Notification of Change

CHDX8-225
CHDX8-225C
CHDX8-325
CHDX8-325C

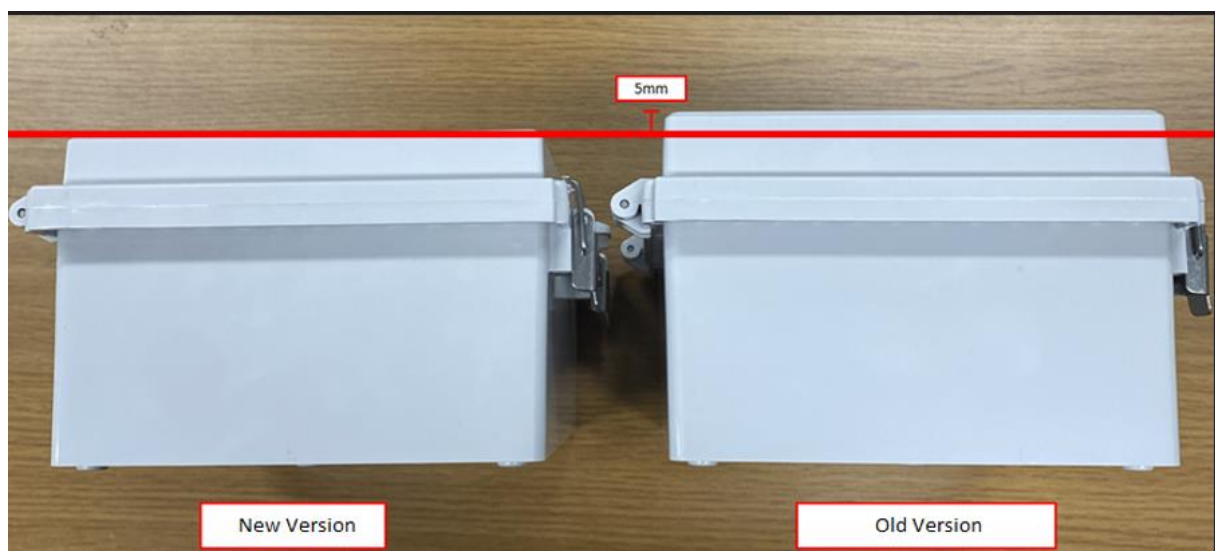
Effects of change: The lid on the new version is 5mm slimmer than previously, result in a total enclosure height of 105mm

The external edges of the enclosure are now more angular/square.

The locking flange point has moved to a central location and the hole is smaller than before.

Also, the roof lip that prevents moisture from getting in the seal has been extended further to the ends of the enclosure and the latches/hinges have moved a bit closer to the corners.
